A G E N D A

Architectural Review Board

August 28, 2018

LAND USE DIVISION

2140 St. Charles Avenue

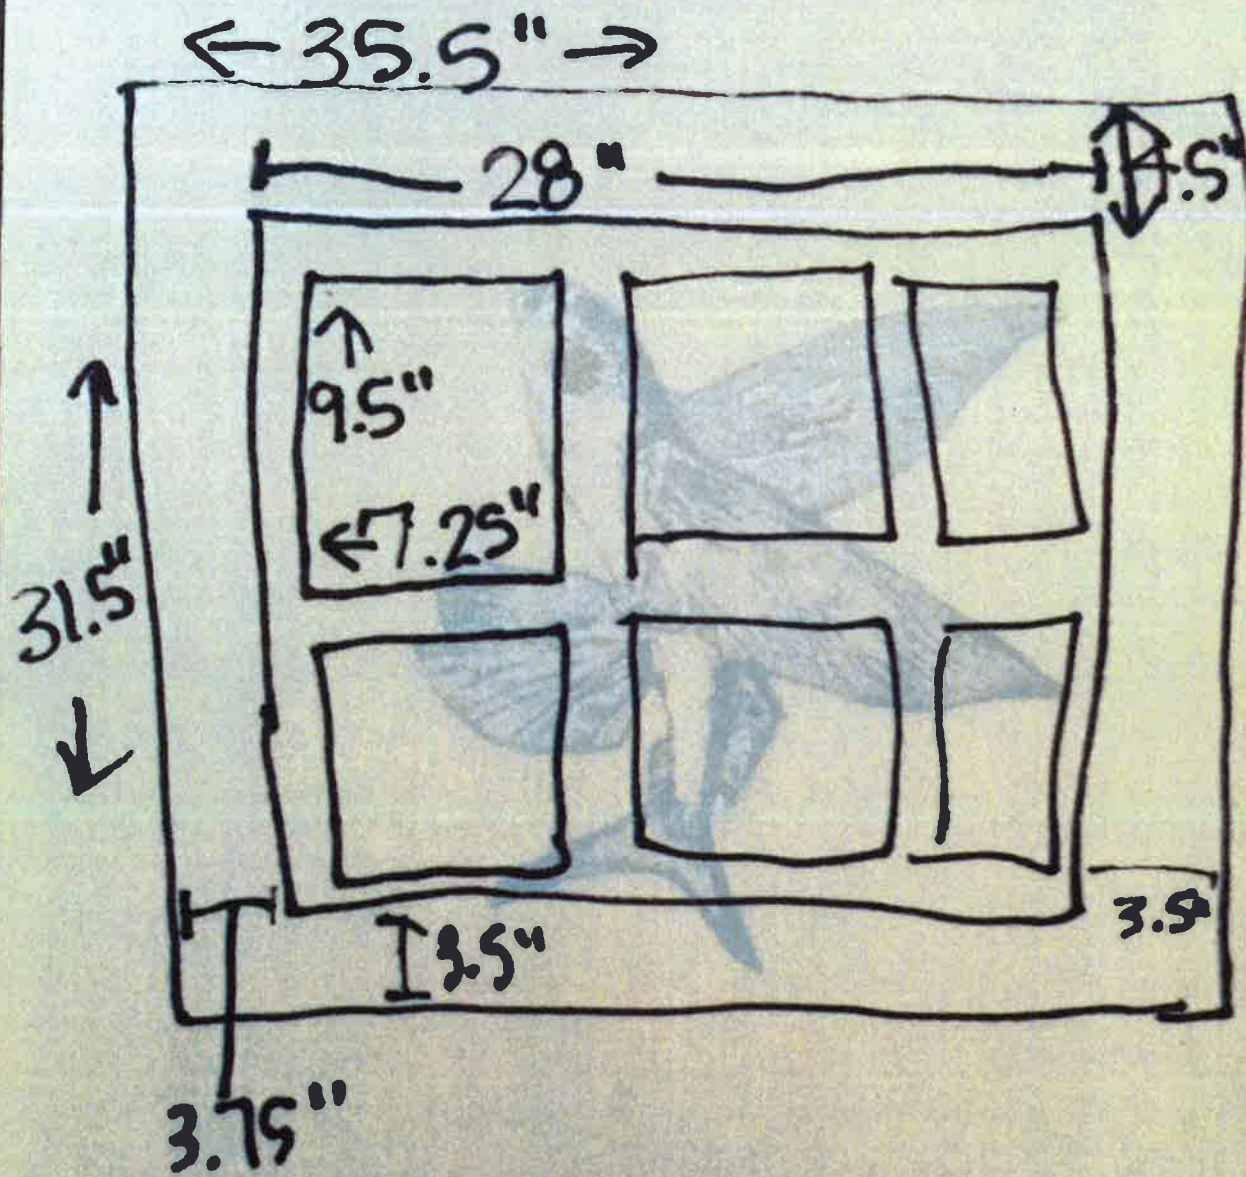
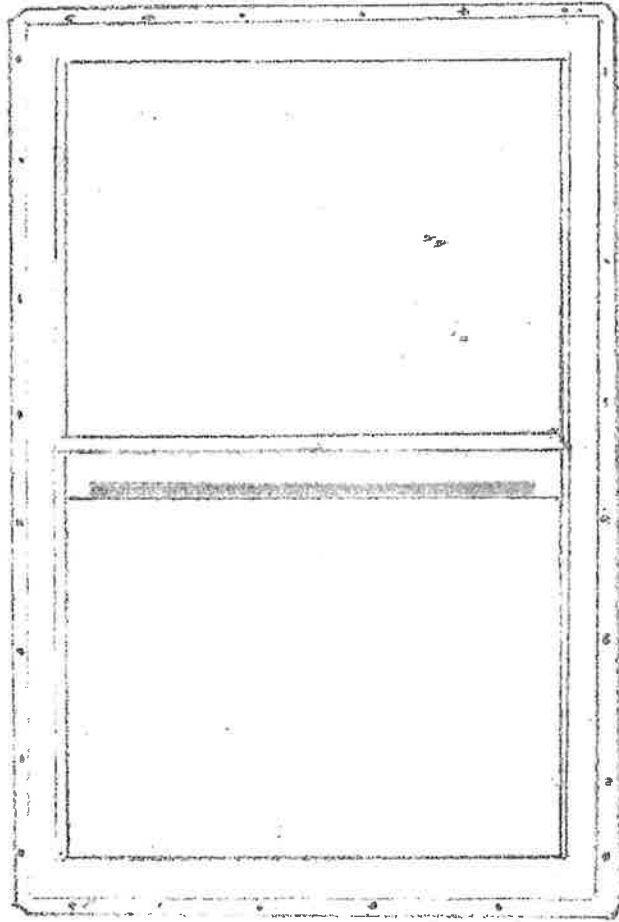
REMARKS: The petitioner is requesting permission to replace a shed window as part of overall renovations to the outbuilding. The existing window is a 6 lite wood awning window facing the house approximately 36" wide and 32" high with trim. The proposed replacement is a vinyl single hung insulated window, 24" wide and 36" high, trimmed to match. The shed is not visible from the street. The petitioner is also making other repairs to the roof, siding and door.

- The Board has been less rigid on material standards for outbuildings.

320 Bellinger Lane

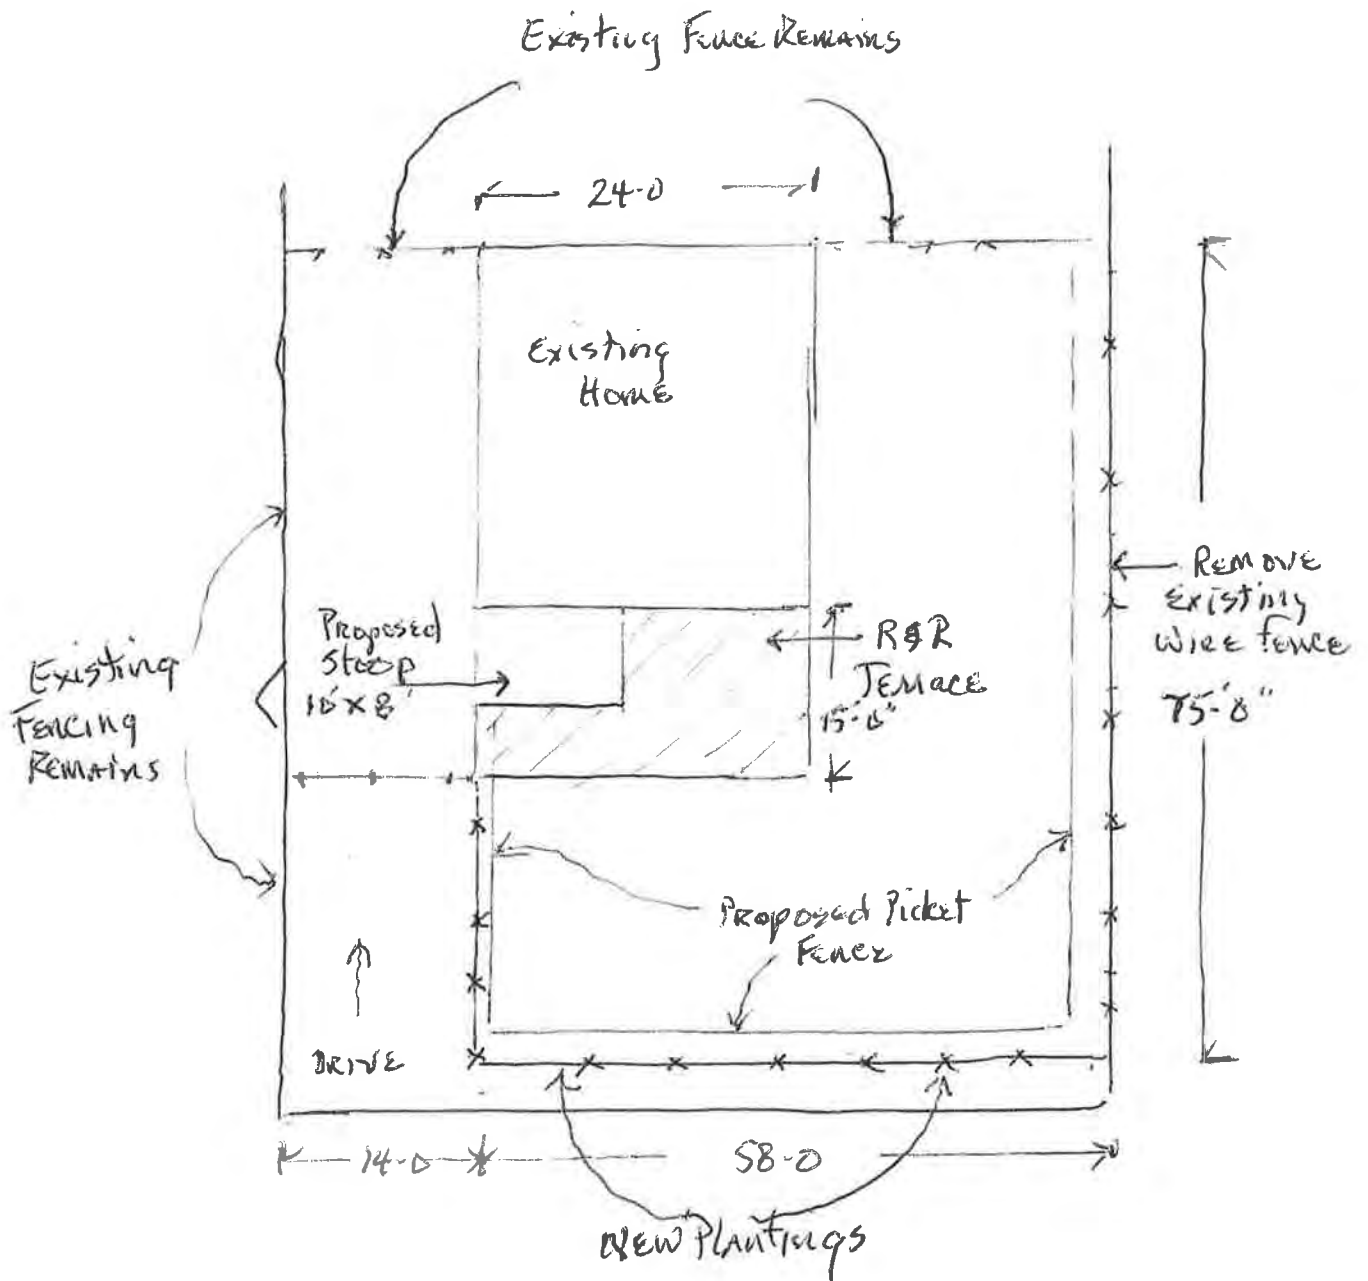
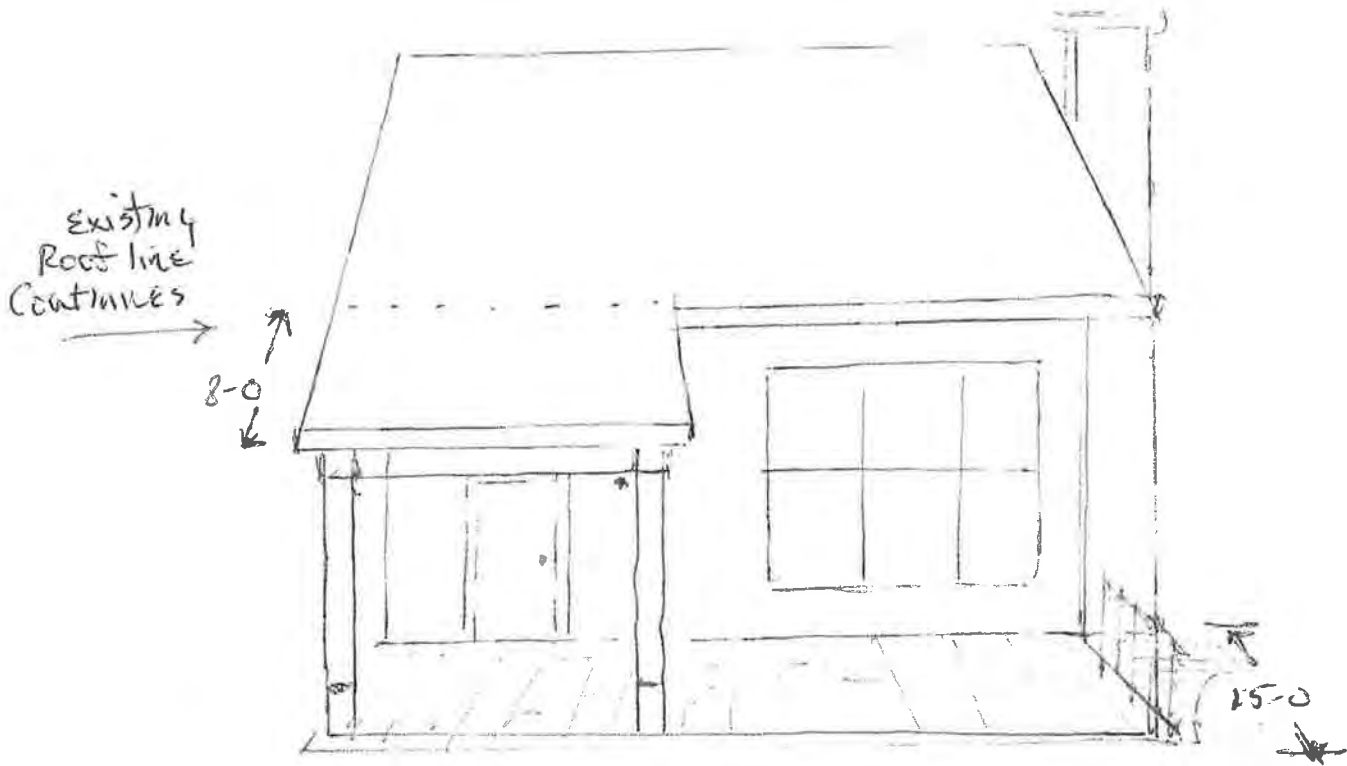
REMARKS: The petitioner is requesting permission to install a wood picket fence in the front and side yard property line in place of an existing wire and wood post fence. Pickets will have a straight point, 36" or 42" high (above 36" requires a variance), 5 1/2 board with 2" spacing based on a section of existing fence. The front fence will be set back from the front property line to accommodate planting shrubs or roses outside the fence.

The proposal also includes extending an 8'x10' section of roof line to cover the front door. The roof would be supported by 4"x6" posts. All elements to be shingled and painted to match the existing structure.

- In the proposed picket pattern, a fence taller than 36" would require a variance from the Board of Adjustment.

LA PLATINES		
LANDSCAPE PLAN		
SCALE 1"=5'-0"	DATE 4/10/2016	SHEET 2 OF 5

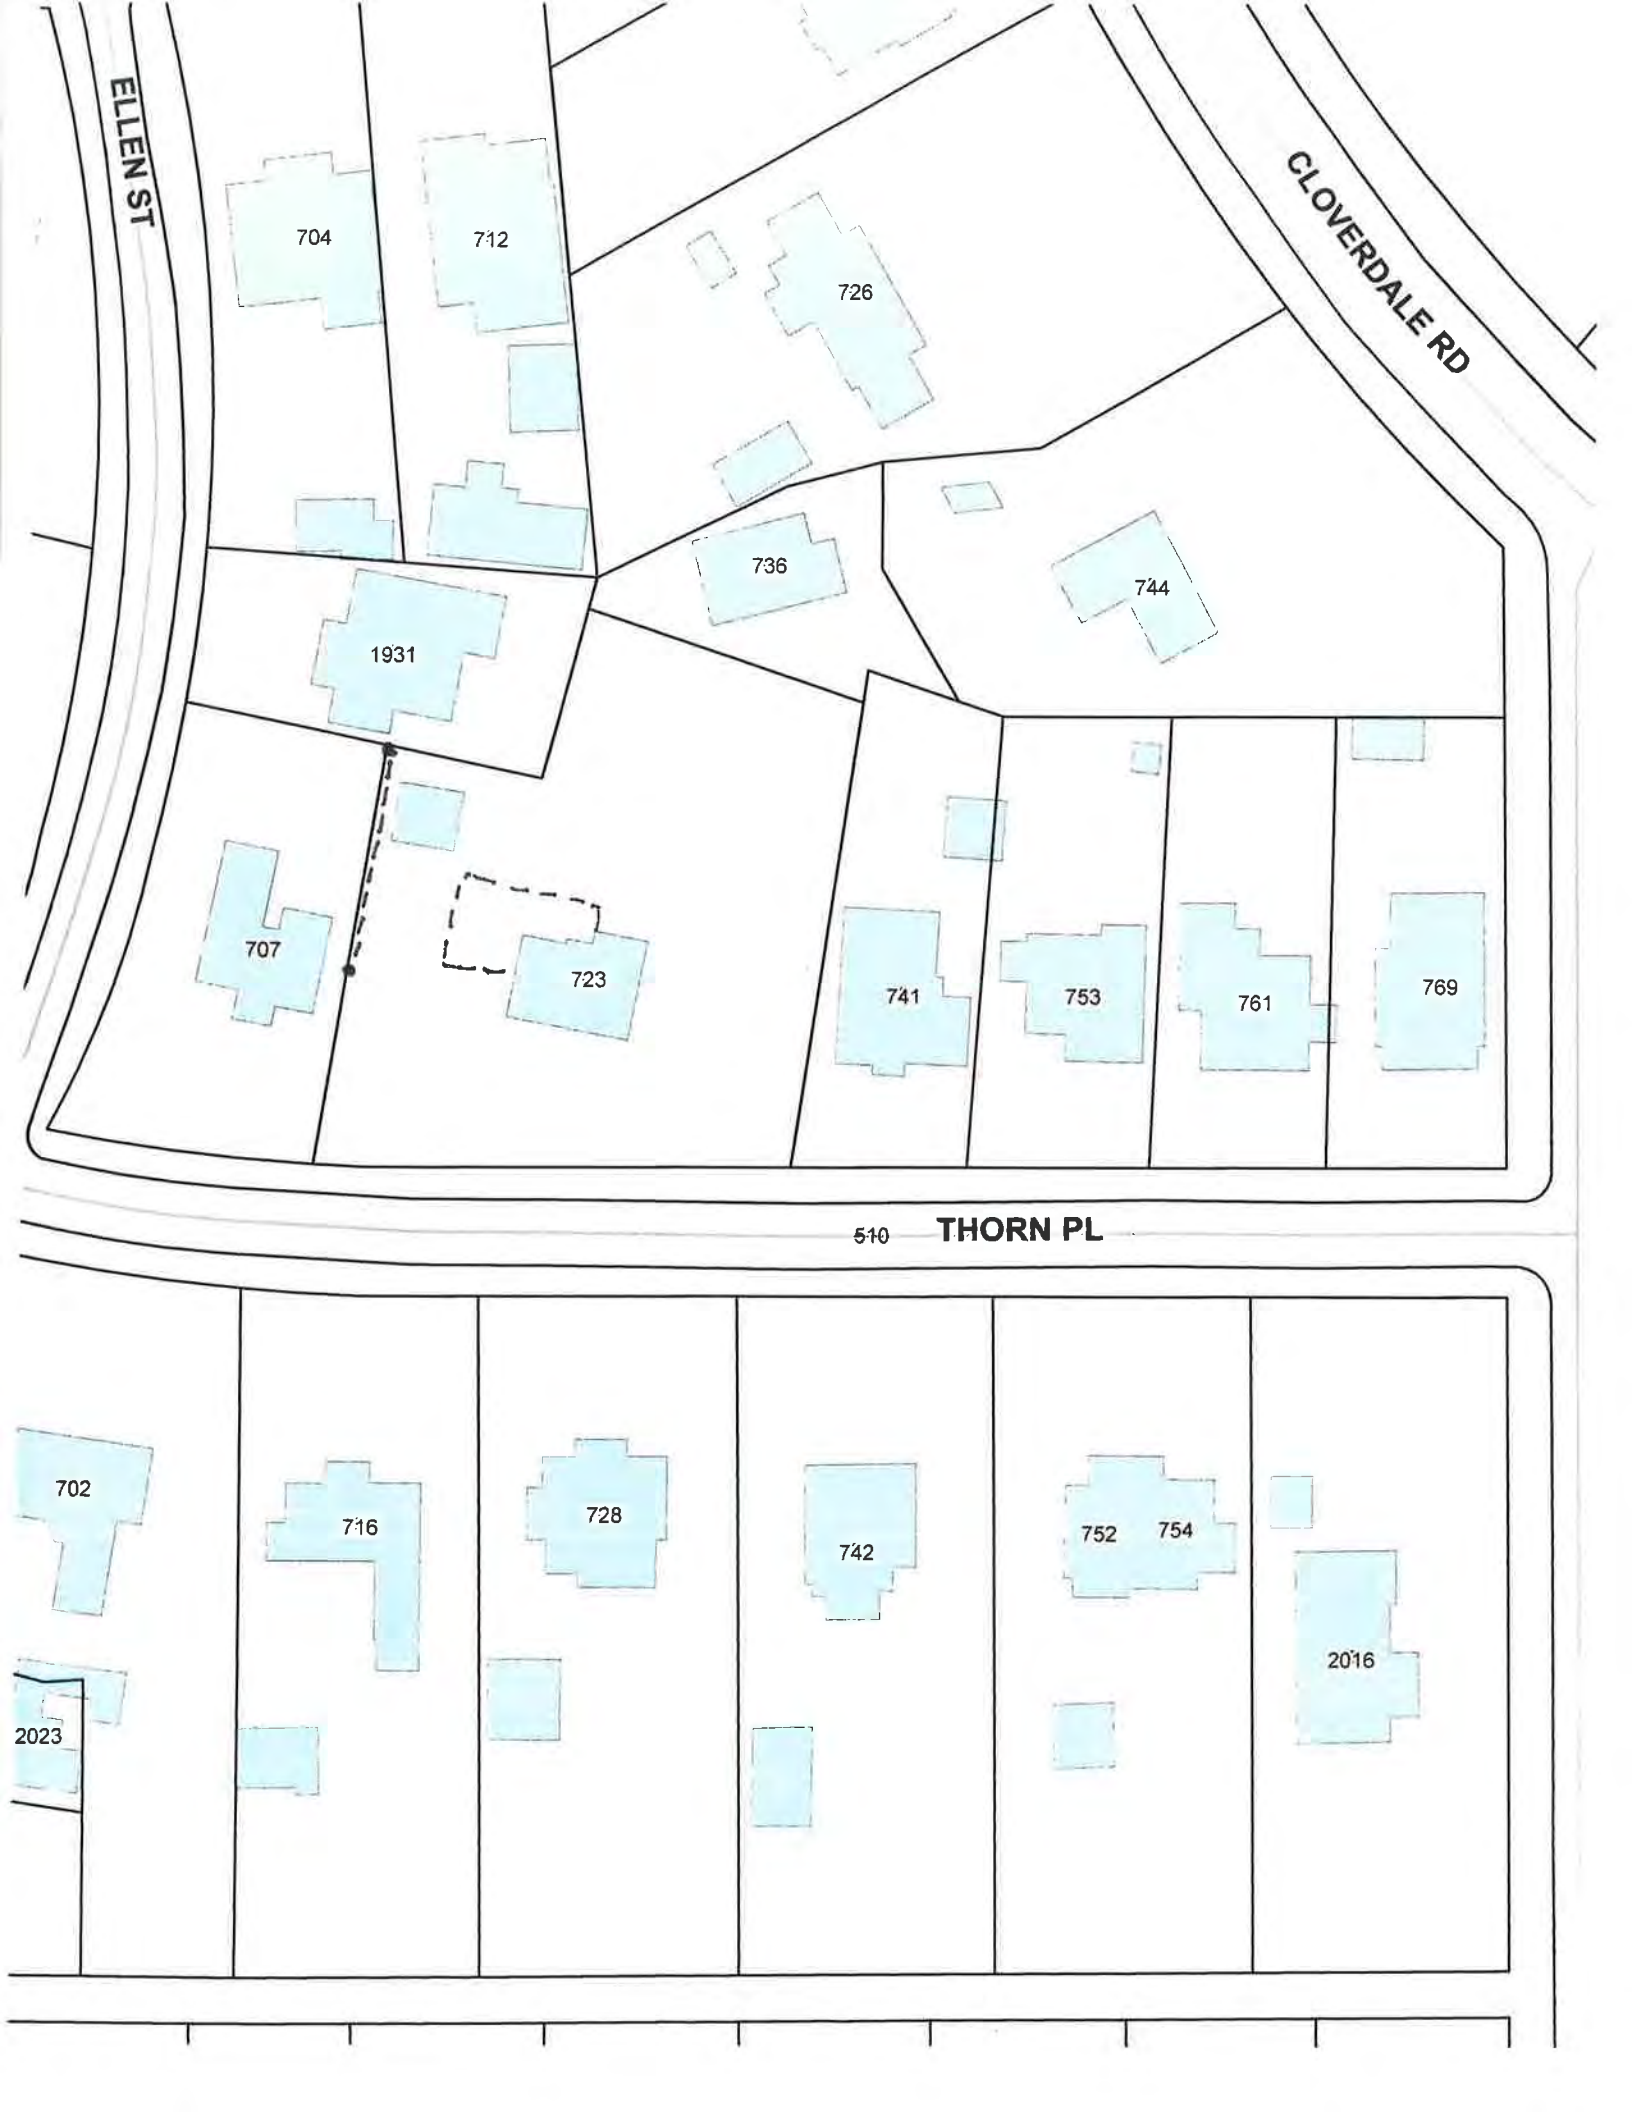
REMARKS: The petitioner is requesting permission to install a privacy fence on the west property line, from the existing fence between the property line and the house, to the rear corner of the property. The fence would replace an existing wire fence.

The petitioner is also requesting permission to install an interlocking paver patio with the accompanying landscape plan, which will largely be screened from the street by the existing fence with vegetation and house.

- The Board has routinely approved rear yard privacy fences.

79 Commerce Street

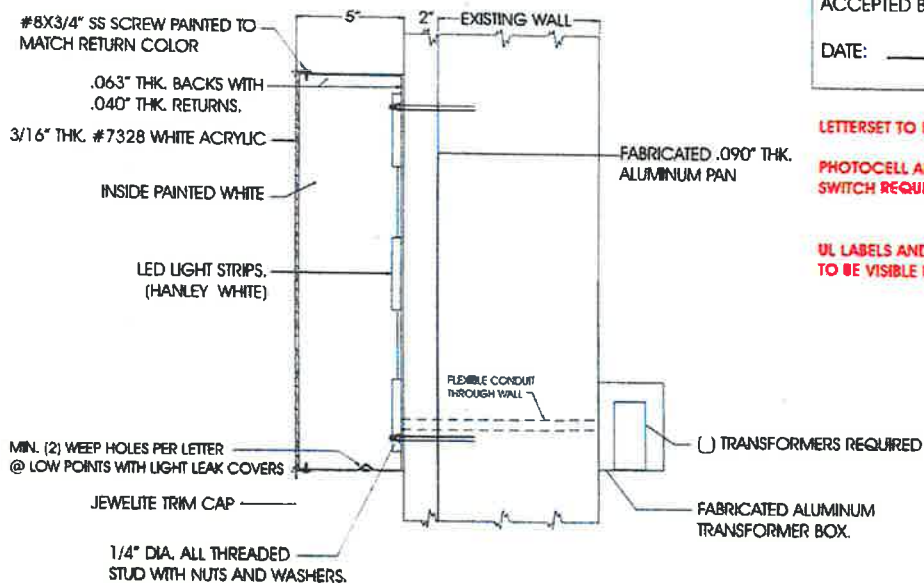
REMARKS: The petitioner is requesting permission to install a 3'6"x13.5 1/2" (48 SF) back panel with individually mounted, face lighted channel letters & logo. Only the letters and logo are illuminated. Sign will read "Strayer University".

- ARB guidelines state signs should not exceed 20 square feet of surface area. Lighting called for is top or ground lighting such as floods or spots, interior lighting if shielded.
- The Board has approved larger signs if they felt the scale was appropriate to the building.
- This is a new building, and approved a sign for Wet Willies next door at 23 square feet, solid face with halo lighting (shielded illumination from behind).
